Commonwealth Edison Company  
Quad Cities Generating Station  
22710 206th Avenue North  
Cordova, IL 61242-9740  
Tel 309-654-2241

ESK-96-049

Subject: Quad Cities Nuclear Power Station Unit 1  
Submittal of Weld Overlay Repair Designs and Flawed Pipe Evaluations  
NRC Docket No. 50-254

# ENGINEERING CHANGE NOTICE

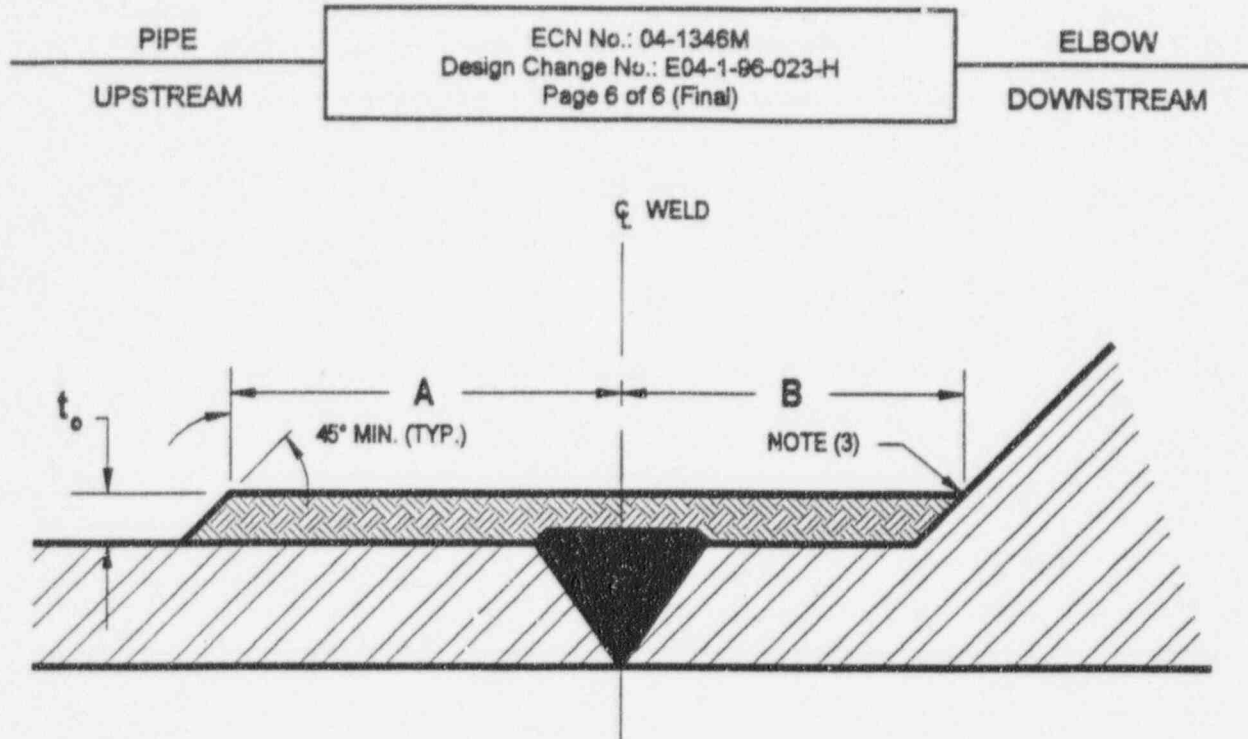
4.1.4	The base materials to which this WOR is to be applied contain low levels of delta ferrite (<5 FN). In an effort to compensate for the dilution effect this low ferrite material will have on deposited weld metal, it is recommended that the weld filler material used for the first layer be selected on the basis of its ability to produce a deposit meeting the requirements of Document No. COE-107-500 (minimum 7.5 FN as-deposited). For the first layer, it may therefore be necessary to use filler material capable of producing an undiluted weld deposit double the minimum acceptable delta ferrite specified in COE-107-500.
